Land-Rover Service Newsletter Vol. 3 No. 15

August 1970

The Rover Company Limited Service Department: Solihull, Warwickshire, England

Fig. 1. Wire mesh guard, front illustrated

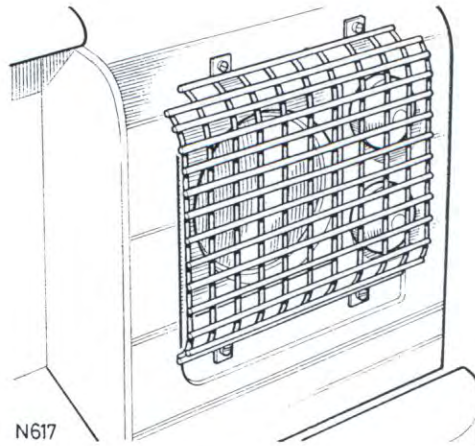
Item 110 SUBJECT: LAMP GUARD

MODELS: Land-Rover Bonneted Control, Series IIA with headlamp in front wings.

MODIFICATION: Introduction of wire mesh guard for the protection of side, stop and flasher lamps.

PART NUMBERS:	Wire mesh guard for front lamps	2	345985	} Series IIA. All Bonneted Control models from vehicle suffix 'G' onwards
	Screw (2 BA x 1/2 in. long)	8	77869	
	Plain washer	8	3816	
	Spring washer	8	3073	
	Nut (2 BA)	8	3823	
	Wire mesh guard for rear lamps	2	320626	
	Screw (2 BA x 1/2 in. long)	4	77869	
	Plain washer	4	3816	
	Spring washer	4	3073	
	Nut (2 BA)	4	3823

It should be noted that the rear wire mesh guards are not affected and are the same as specified for vehicles prior to chassis suffix letter 'G'.
